Rapid Update 654

Granturismo – Door-fender gap & flush check

DATE: SEPTEMBER 21 2023

Certain Maserati GranTurismo (189) MY24 are involved in a Rapid Update to carry out a door fitment inspection procedure due to an interference with the fender.

Measuring points
Following instruction on page 3

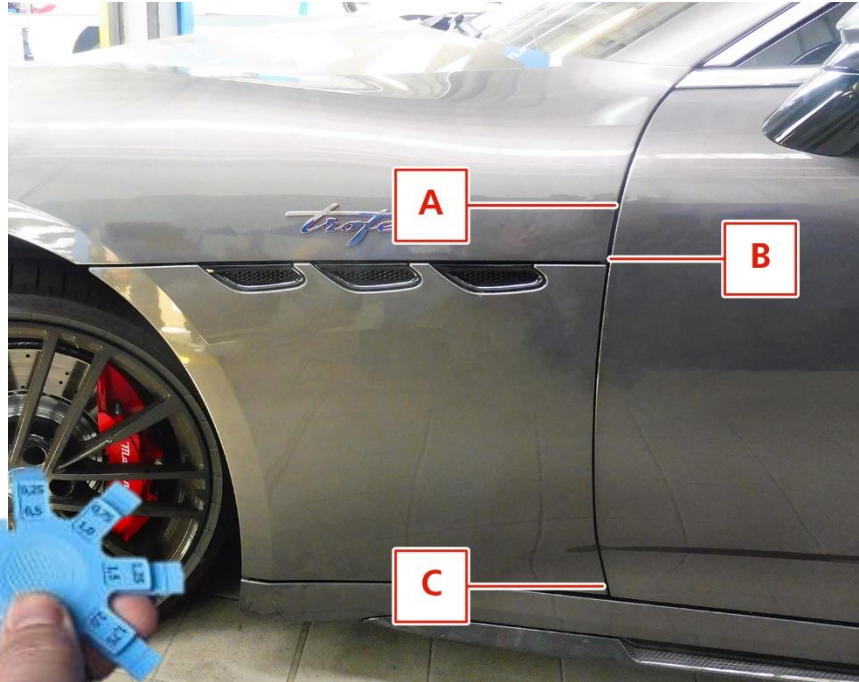
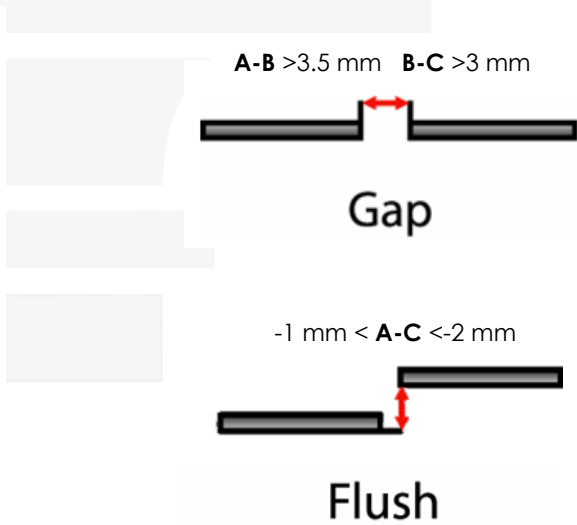
Use a suitable gauge, check the relative positions of the hood, fender, and door.

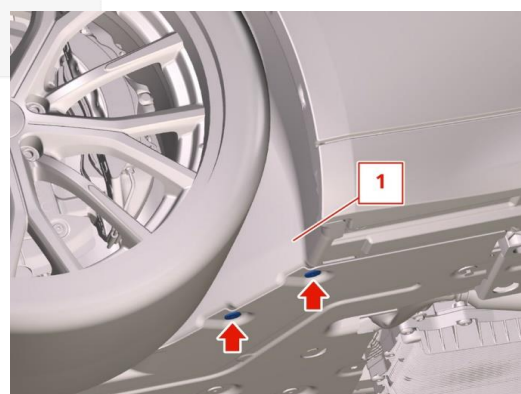
Always consider the **fender** as a **reference**, check:

o from point **A** to point **B**:

- The **GAP** (distance in the longitudinal direction) must be > 3.5 mm
- The **FLUSH** (distance in transverse direction) must be between -1 mm and -2 mm

o from point **B** to point **C**:

- The **GAP** must be > 3 mm
- The **FLUSH** must be between -1 mm and -2 mm

2. If the measurements are correct, the car is **OK** and no further adjustments need to be made.
3. If one or more measurements do not fall within the range described, continue with the adjustment based on the following parameters.
4. If the **GAP** between **A and B** is more than 3.5 mm, proceed with the **adjustment of the front hood** on the X-axis.
5. If the **FLUSH** between **A and B** is **not** between -1mm and -2mm, proceed with the Y-axis **fender adjustment**.
6. If the **GAP** between **B and C** is more than 3 mm, proceed with the adjustment **of the fender** on the X-axis.
7. If the **FLUSH** between **B and C** is **not between -1 mm and -2 mm**, proceed with Y-axis **fender** adjustment. Follow the correct procedure reported in the bulletin.

Fender adjustment

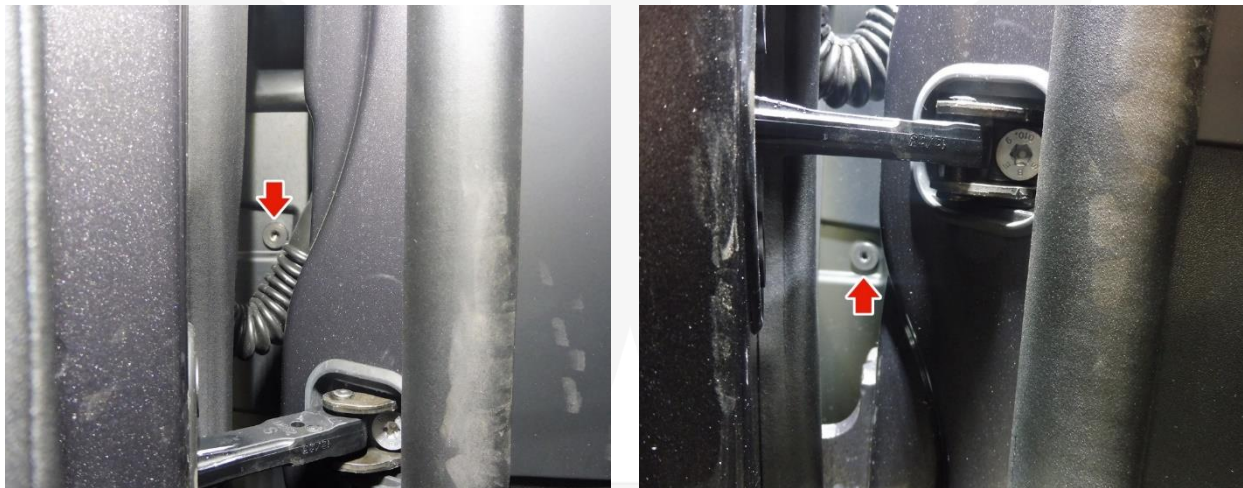
3. Move the fender liner away as shown to reach the rear of the fender. At the rear of the front

fender (1), using a short Phillips screwdriver (stubby), loosen the screw indicated.

4. Open the door slightly and loosen both the upper and lower screws in the side area of the front fender.

5. When opening the front hood, loosen the indicated screws of the front fender. The front fender is now free to move. Adjust its position according to the preliminary check, by moving it in the X-direction (from right to left, longitudinally to the vehicle) or in the Y-direction (pushing or pulling, transversely to the vehicle) until the correct positioning is achieved.
